Permit Number: 041129

This is to certify that Somers Frederick P &/Ledd  
has permission to Single Family Home w/ ~~112~~ garage Garage  
AT 110 Ledgewood St 110 Ledgewood St

**Dept:** Building      **Status:** Approved with Conditions      **Reviewer:** Jeanine Bourke      **Approval Date:** 11/01/2004

**From:** Eric <eric@whittenarchitects.com>  
**To:** <jmb@portlandmaine.gov>  
**Date:** 10/14/2004 1:22:50 PM  
**Subject:** Somers Residence-Peaks Island (Permit Add)

6 STAIR DETAIL (BOTH SIDES)  
SCALE: 1/2" = 1'-0"

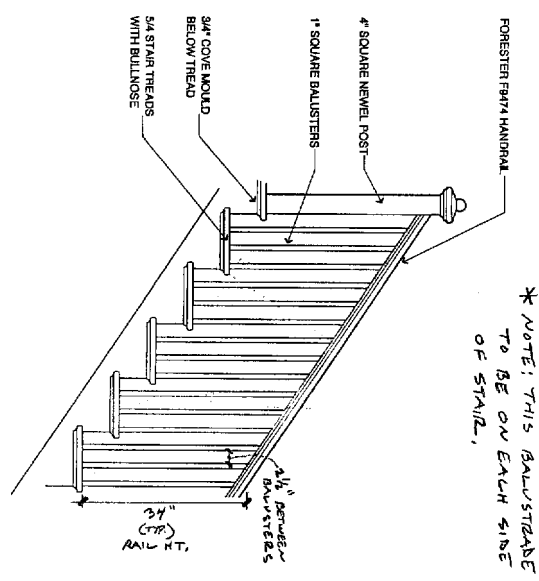
1. Stair balustrade: this will be a fairly typical rail assembly, with a standard handrail at 340 above the tread nosing, and three square balusters per tread (approx. 2 1/20 clear opening between each). The balustrade will be located on both sides of the stair, so that we should not have any issues with the windows on the exterior wall (these will be tempered per code). The stair will conform to the 2003 IRC specifications. Please refer to sheet 1 in the pdf.

SECOND FLOOR PLAN

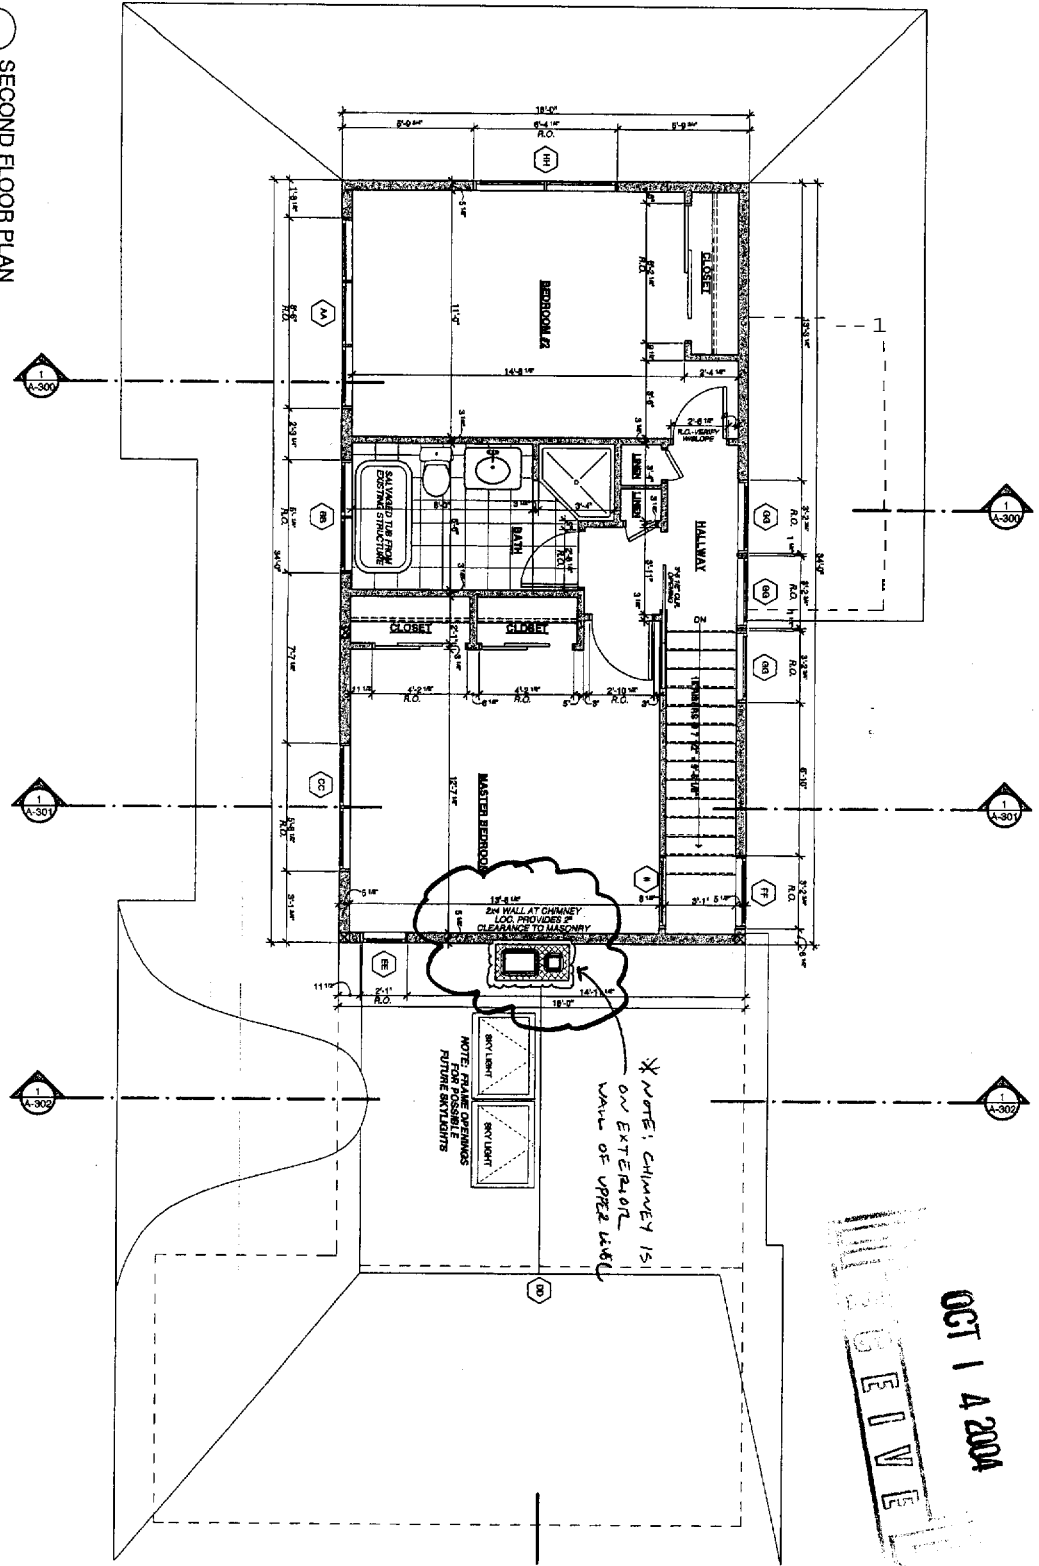
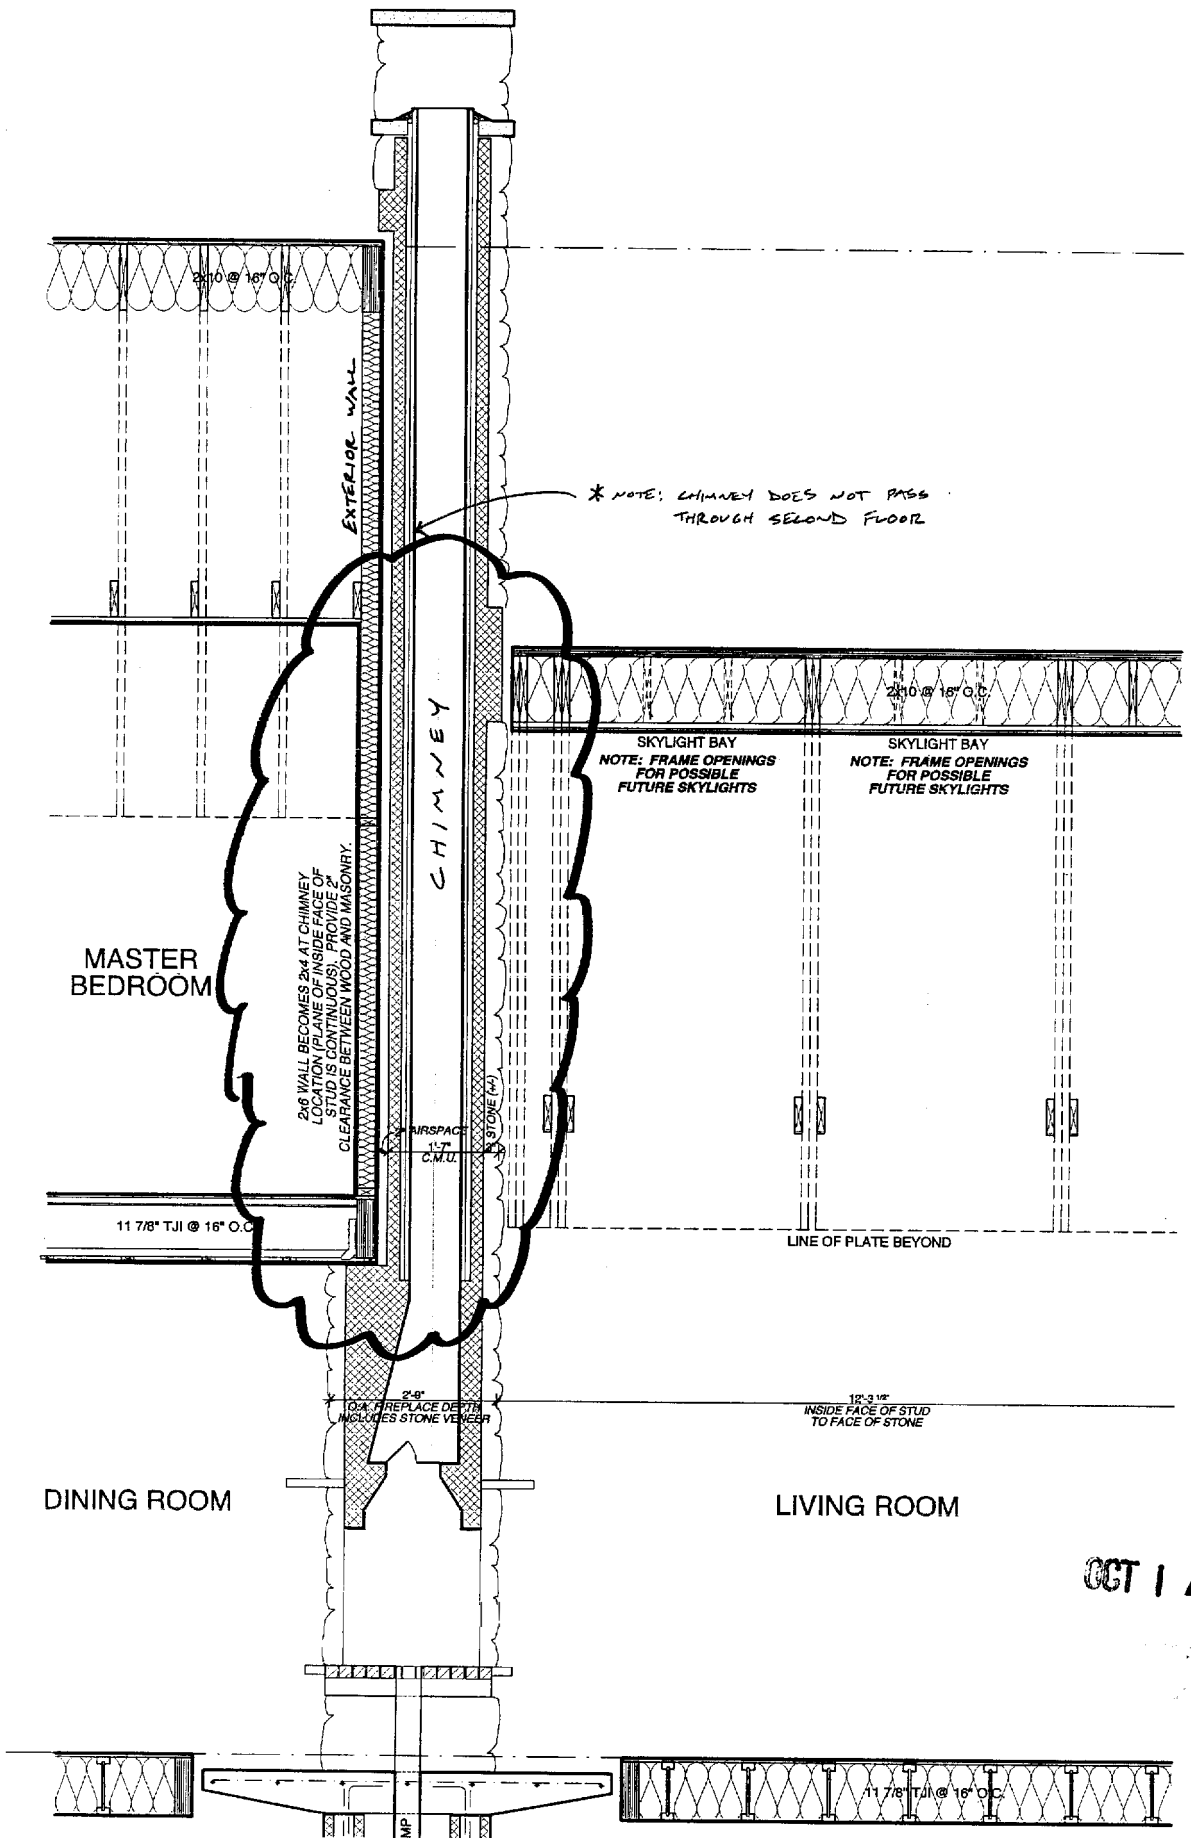
2. Chimney: the chimney will not pass through the interior spaces of the upper level. It emerges through the roof of the Living Room and runs alongside the exterior wall of the master bedroom. We are maintaining the 2" required airspace throughout. Please refer to sheets 2 and 2A in the pdf.

\* NOTE: CHIMNEY DOES NOT PASS THROUGH SECOND FLOOR

2x6 WALL BECOMES 2x4 AT CHIMNEY  
 C.M.U. IS CONTINUOUS PROVIDING  
 CLEARANCE BETWEEN WOOD AND MASONRY
